**PROPERTY: 9 WANDEEN ROAD CLAREVILLE  
DA2020/1772 FOR DEMOLITION WORKS AND CONSTRUCTION OF  
DWELLING HOUSE INCLUDING SPA POOL**

This letter responds to Northern Beaches Councils letter dated the 29<sup>th</sup> of March 2021, in respect of development application (DA2020/1772).

221 Hudson Parade – Layout Courtesy McGrath

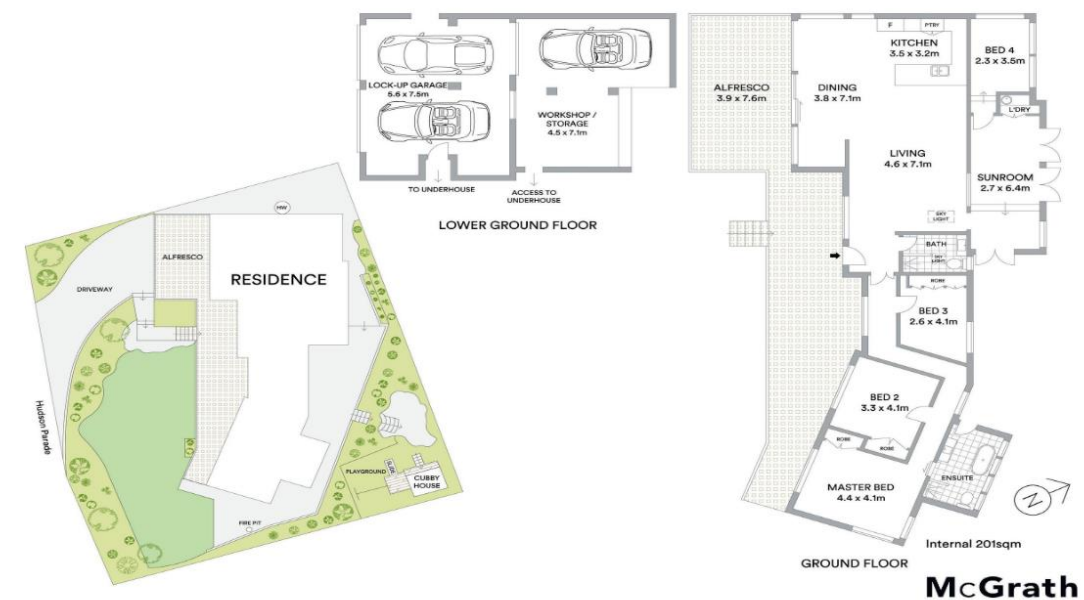
The above definition is important, as it provides a guide to interpreting the location of PPOS which is the term described but not defined within the PDCP 2014. The definition above supports our claim, that the PPOS for 221 Hudson Parade is the area adjacent to the living room and kitchen of that dwelling house, and which is facing south towards the vista. This definition in turn supports a contention that the northern open space for No 221 Hudson, is not that dwelling's PPOS.

See floor plan below which illustrates this point.
